DAVIS-BESSE NUCLEAR POWER STATION, UNIT NO. 1

Amendment No. 42
License No. NPF-3

ATTACHMENT TO LICENSE AMENDMENT NO. 42

SAFETY EVALUATION BY THE OFFICE OF NUCLEAR REACTOR REGULATION
SUPPORTING AMENDMENT NO.42 TO FACILITY OPERATING LICENSE NO. NPF-3

3.2.1 AXIAL POWER IMBALANCE shall be maintained within the limits shown on Figures 3.2-1a, -1b, -1c and 3.2-2a, -2b, -2c.

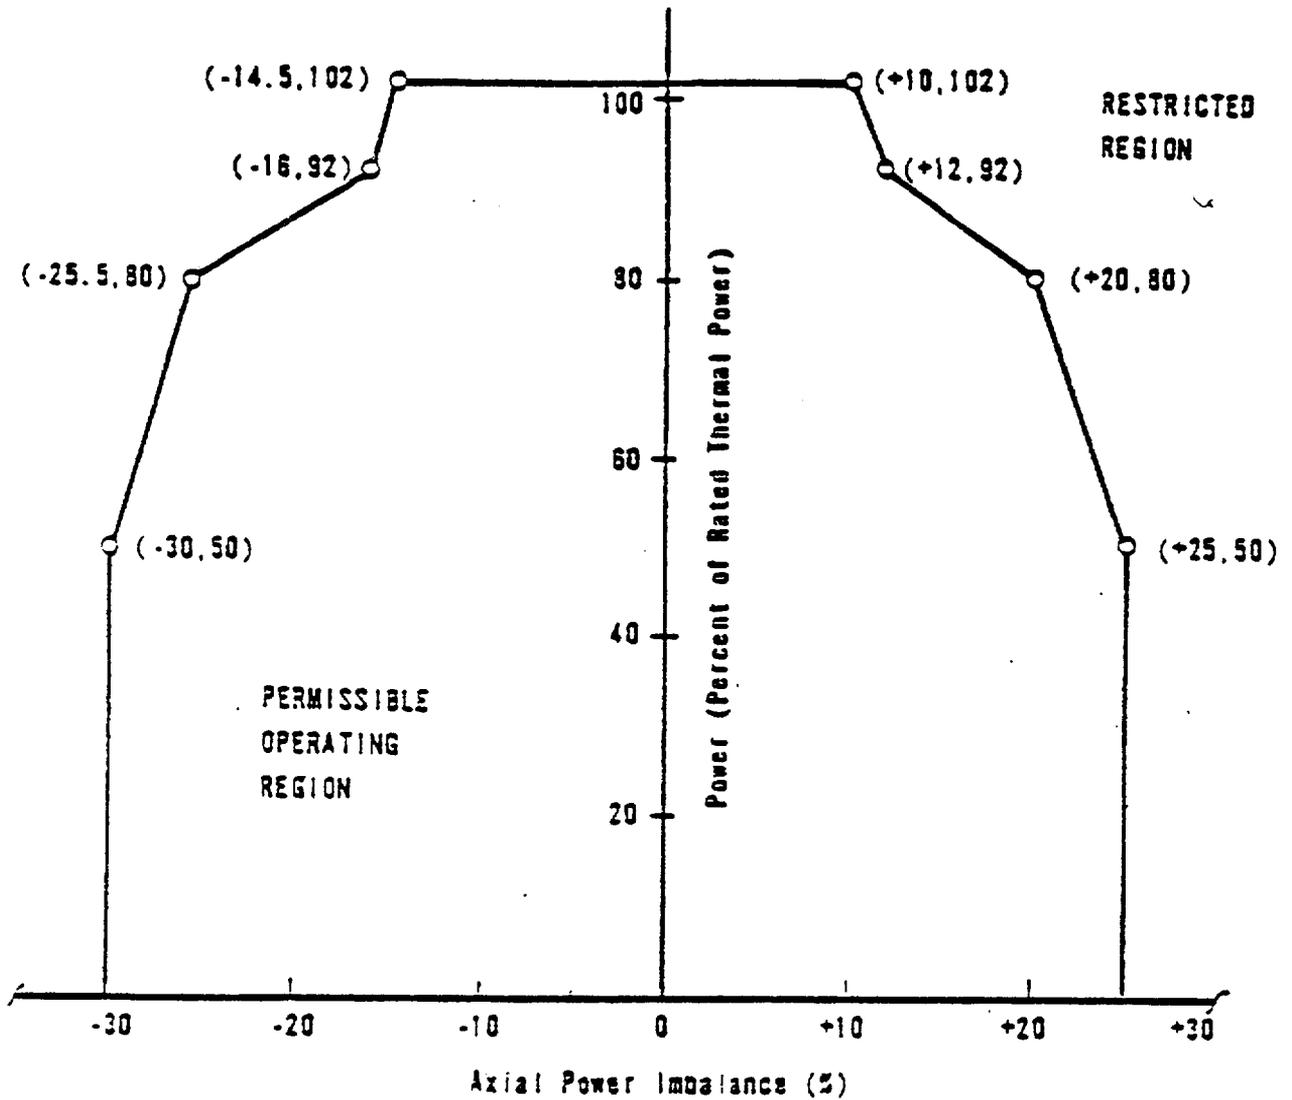
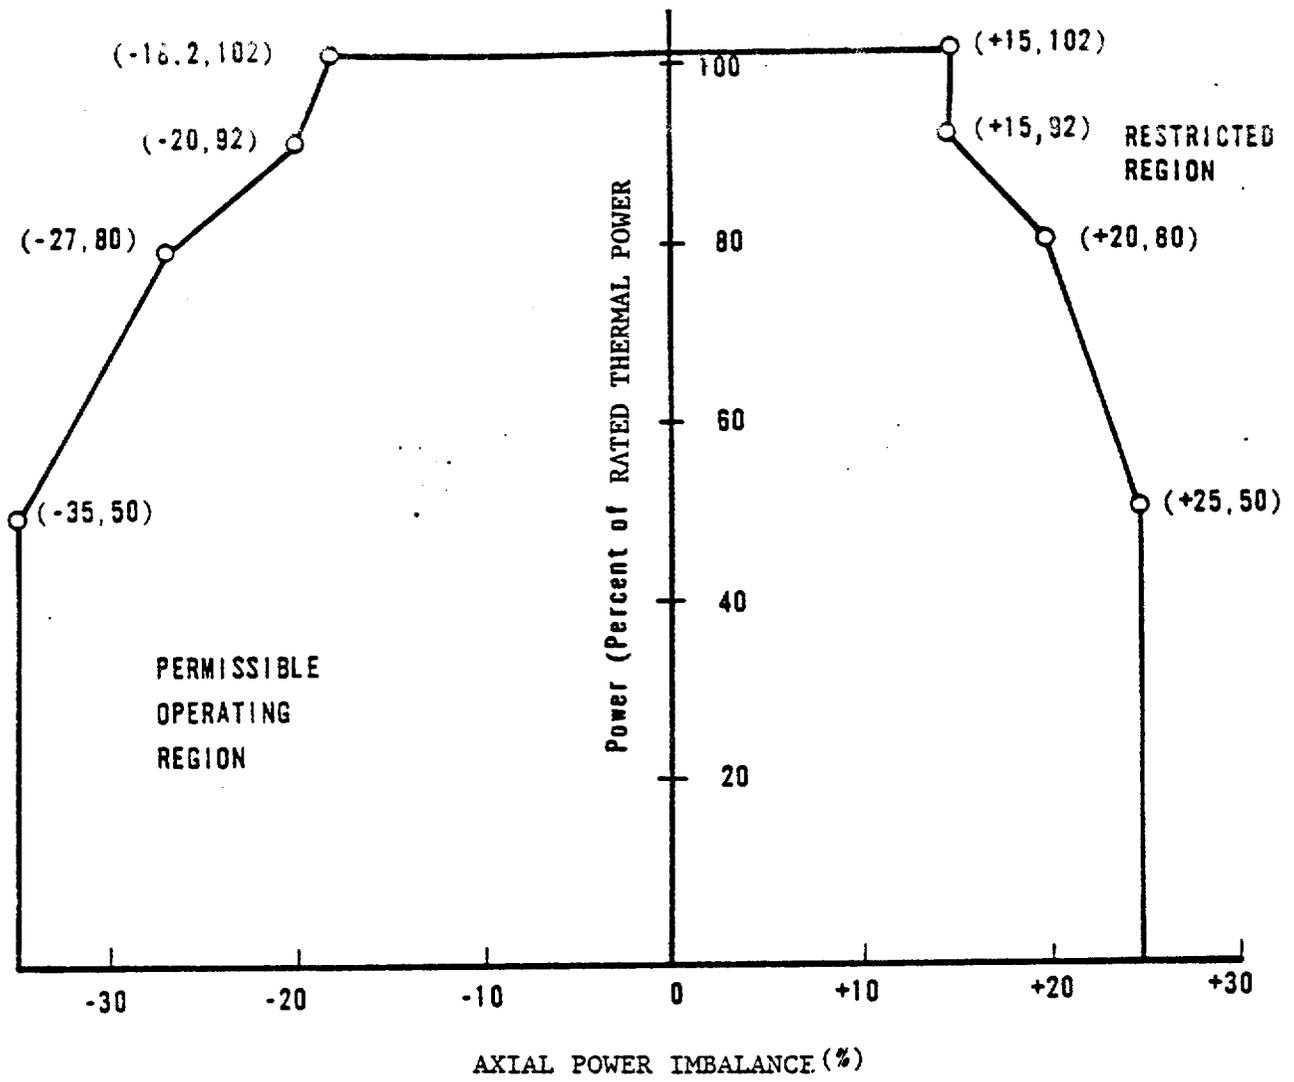
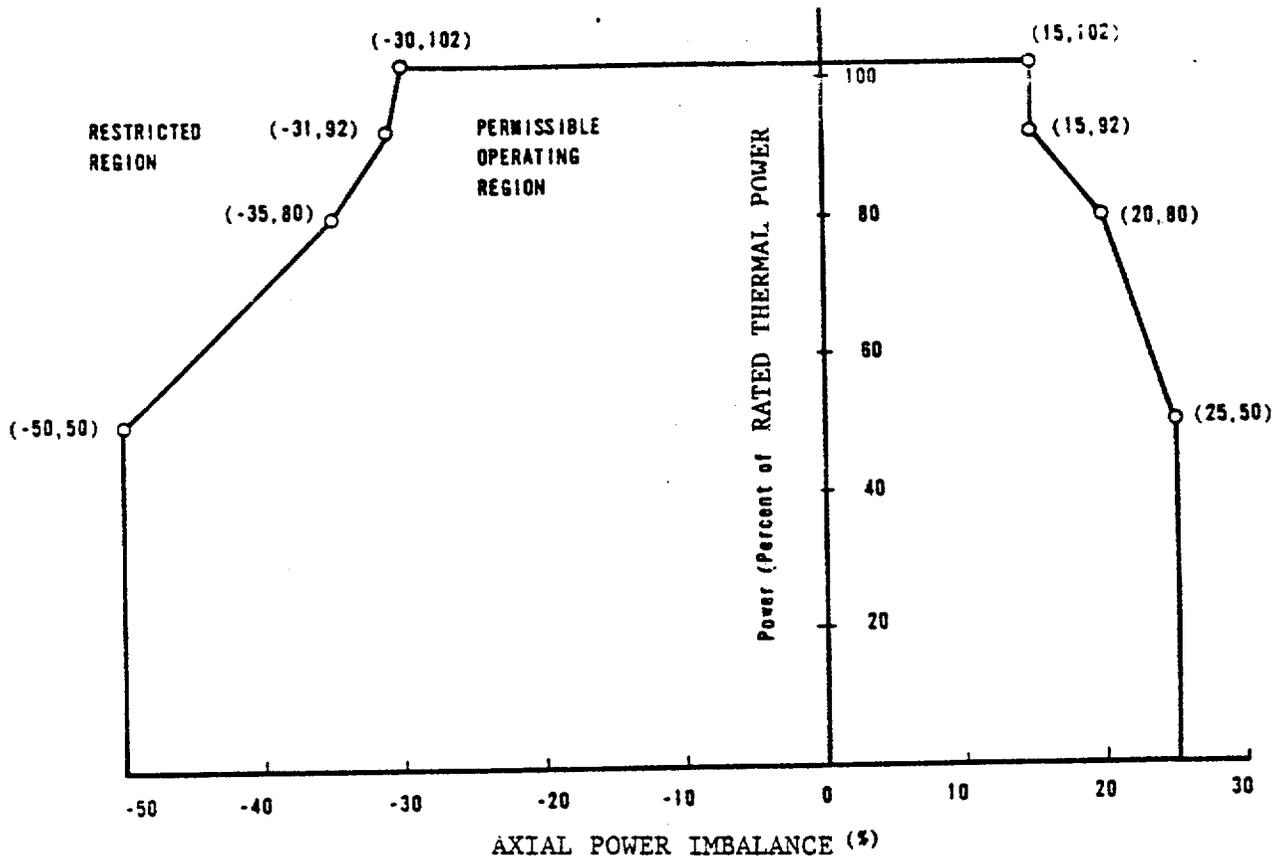
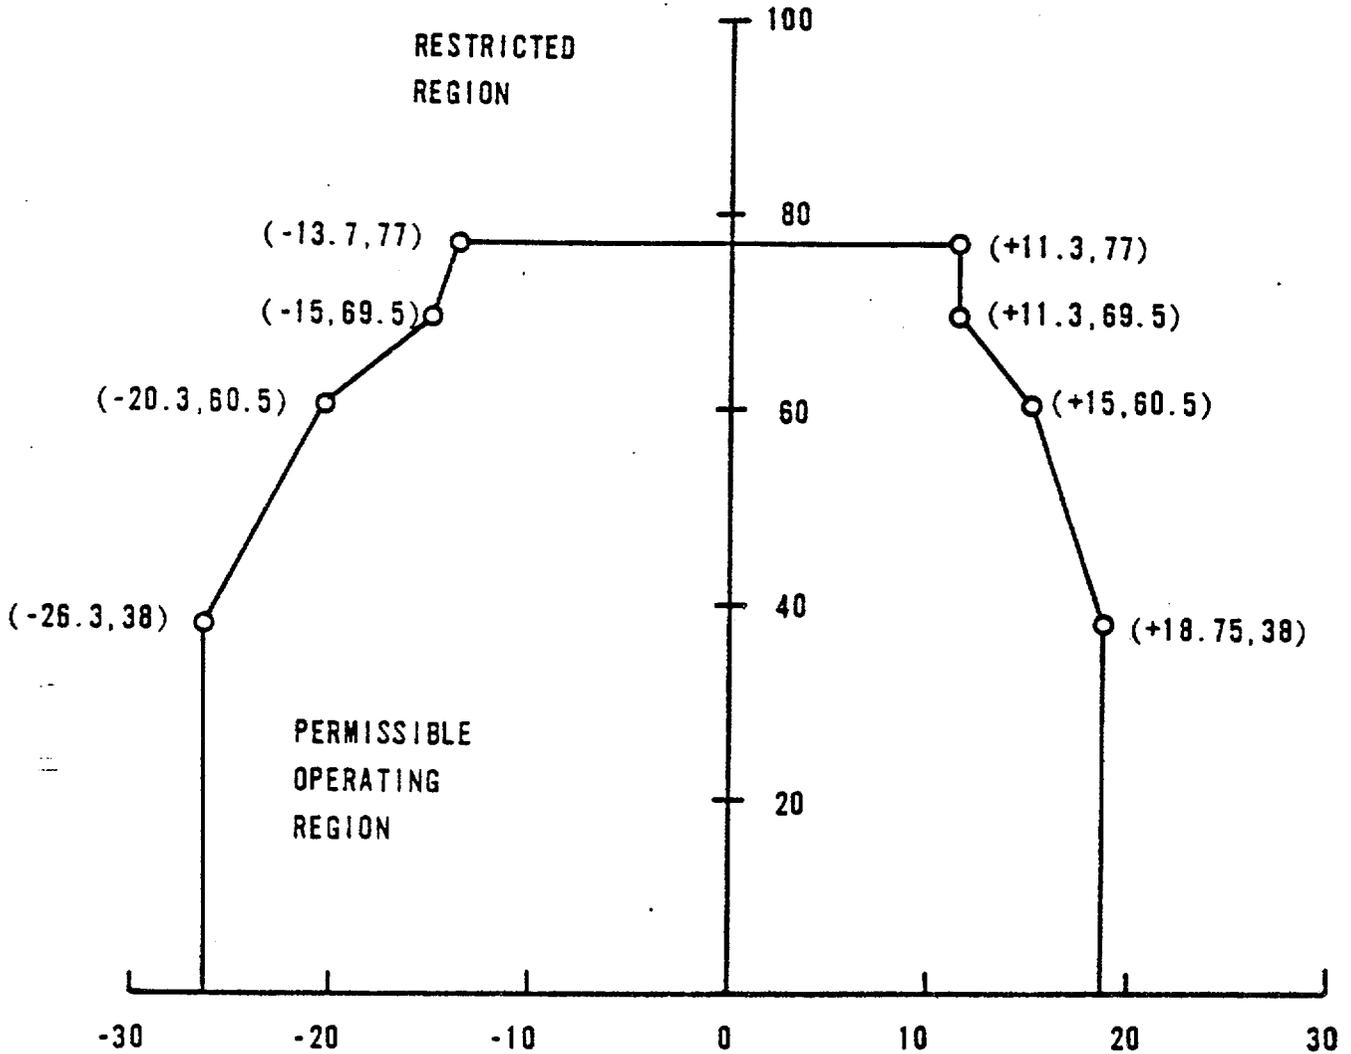
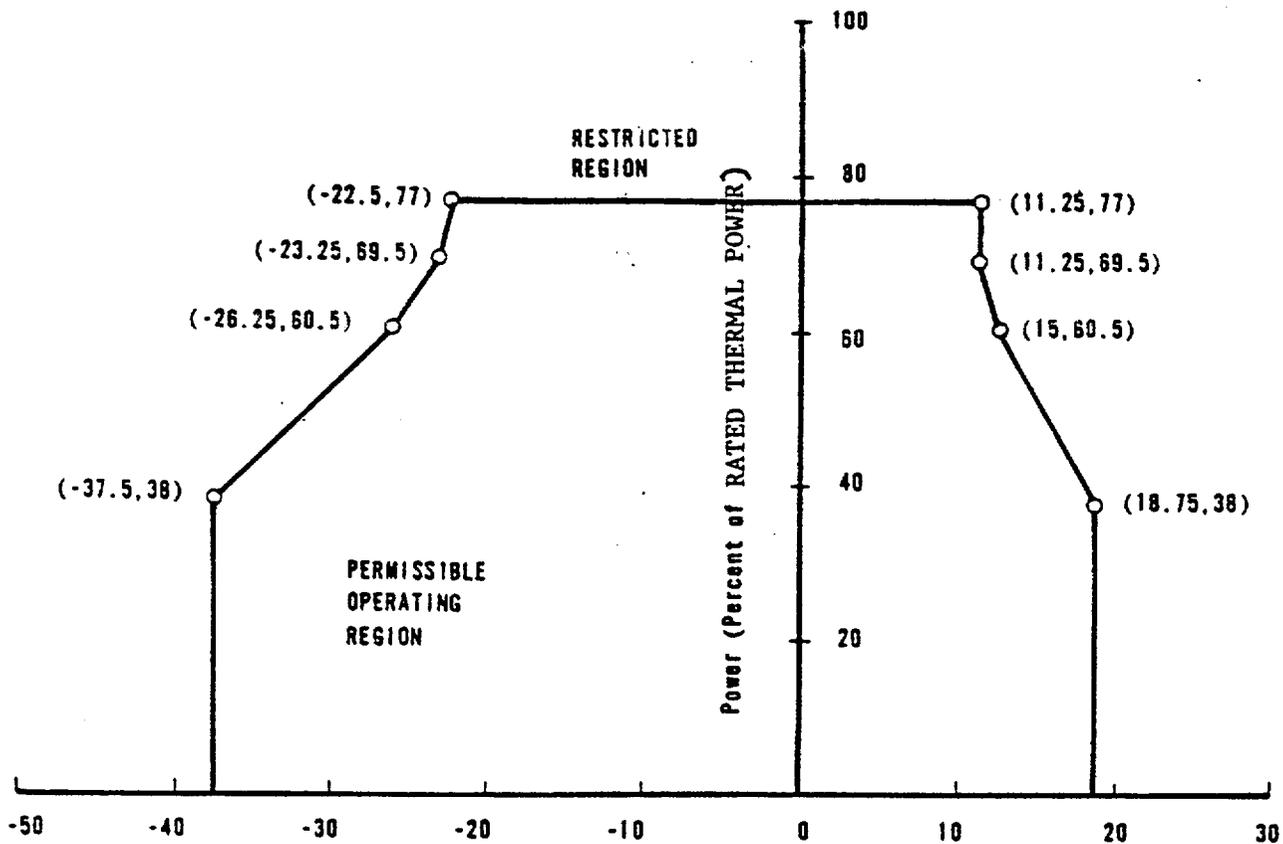
With AXIAL POWER IMBALANCE exceeding the limits specified above, either:

- a. Restore the AXIAL POWER IMBALANCE to within its limits within 15 minutes, or
- b. Within one hour reduce power until imbalance limits are met or to 40% of Rated Thermal Power or less.

The present TS Limiting Conditions for Operation, 3.2.1, requires that if the axial power imbalance exceeds specified limits, the power imbalance must be restored to within the limits within 15 minutes or the unit must be brought to hot-standby within 2 hours. TS 3.2.1 is applicable only when the unit is operating above 40% of rated thermal power; at 40% or less of rated power there is no Limiting Conditions for Operation applicable to axial power imbalance. The proposed modification to the action requirement would relax the requirement to place the unit in hot-standby by requiring that within one hour the unit's power be reduced until imbalance limits are met or to 40% of rated thermal power or less. Because of the shape of the axial power imbalance limit envelope, a reduction in power may bring axial power imbalance within permissible limits. At 40% of rated power or less, the limiting condition for operation is no longer applicable. This proposed modification reduces the requirement for rapid shutdown of the unit since thermal power can be readily reduced within the specified time to restore axial power imbalance to within limits or to 40% rated power or less. We find this proposed TS modification acceptable.
